Derived from the devastating wildfires of 2016 and 2017, California Public Utilities Commission (CPUC) opened Rulemaking 18-10-007 to provide guidance on the Investor-Owned Utilities (IOU) Wildfire Mitigation Plans (WMPs). Moving forward, California Legislature passed several bills increasing the oversight for the investor-owned utilities (IOUs) as it related to mitigating wildfires associated with electrical corporation's infrastructure role in utility-related wildfires. This resulted in key legislative measures, Senate Bill 901 (2018), Assembly Bill 1054 (2019), and Assembly Bill 111 (2019). Since the passing and ratification of this legislation, the Wildfire Safety Division (WSD) of the California Public Utilities Commission (CPUC) transitioned to the Office of Energy Infrastructure Safety (OEIS)/ Energy Safety at the California Natural Resources Agency (CNRA) on July 1, 2021. The wildfire mitigation process requires utilities to submit their annual Wildfire Mitigation Plan (WMP) in a 3-year cycle. The initial WMP is submitted in the first year (2020) and follows with annual updates occurring for years 2 (2021) and 3 (2022).

Pursuant to P.U. Code Section 8386.3(c)(2)(B)(i), (ii

Figure 15: Historical 2021 Google Earth Imagery Comparison to 2023 PHR1A Imagery The above satellite verification area represents 4,912 trees removed in 0.31 circuit miles

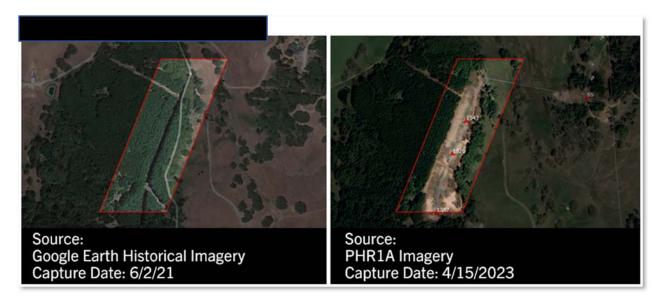
The IE team incorporated the provided information into its field sampling plan with an initial target of 125 circuit miles. The goal was surpassed, with the IE team field verifying 177 circuit miles, exceeding the target by 52 miles, encompassing over 33,000 trees across 43 circuits. To further verify patterns and trends associated with the tree removal work, the IE team validated an office-based sample of an additional 20 circuit miles, utilizing high-resolution satellite imagery sourced from the Pléiades Neo (PNEO4) and the Pléiades 1A (PHR1A) satellites, courtesy of Airbus Defense & Space. In reviewing the satellite imagery, the reported tree removal work matched the information and areas of work completed provided by PG&E; refer to the imagery samples depicted in Figures 15 and 16 below. Upon a thorough review of the data provided and the IE team's field verification samples, it appears likely that PG&E fulfilled its commitment of 1,800

EVM circuit miles and exceeded it by an additional 123.8 miles for a total of 1,923.8 circuit miles as reported.

Figure 24: Historical 2021 Google Earth Imagery Comparison to 2023 PHR1A Imagery

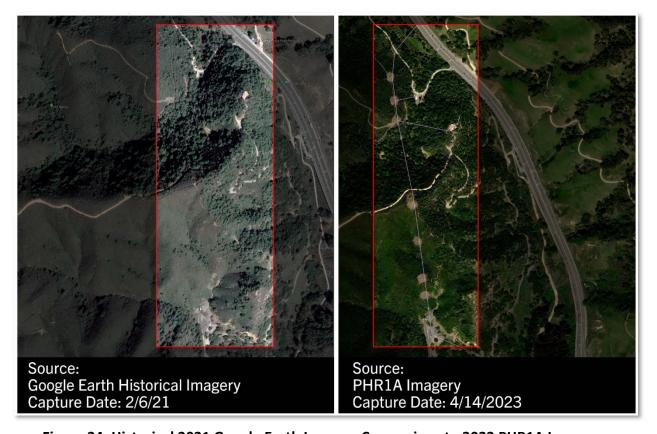
Using the information provided in the data request, the IE field verified a sample of 205 distribution structures in HFTD areas cleared in 2022. Two hundred two distribution structures complied with the initiative requirements, and three (3), or 1.46% of the sampled locations, were found to be out of compliance. The three sites have old logs and brush within the 50' buffer area. Upon a thorough review of the data provided and the IE team's field verification samples, it appears likely that PG&E fulfilled its commitment of 7,000 poles, as reported. However, the data could not verify the reported exceeded the quantity of 7,168 distribution poles due to the 1.46% discrepancy. Field assessments of the pole clearings were reviewed for workmanship quality, the accuracy of the information, and compliance with the initiative. Additionally, the IE team reviewed how PG&E selects, executes, closes, and tracks the overall Utility Defensible Space - Distribution Program initiative and its various process flows and found them to align with the initiative description as described within the 2022 WMP. During the field assessment, we identified several issues. In addition, the IE team attentively tracked the patterns of regrowth, particularly as increased seasonal rainfall is stimulating the proliferation of vegetation. Figures 25 and 26, presented below, provide visual representation of these observations.

- Three (3) locations exhibit the presence of old logs, brush, and debris within the 50-foot buffer zone.
- Eight of the inspected structures, while appearing to have complied with the 2022 regulations, have experienced moderate vegetation regrowth, See Figure 25 presented below for a visual representation of these observations.
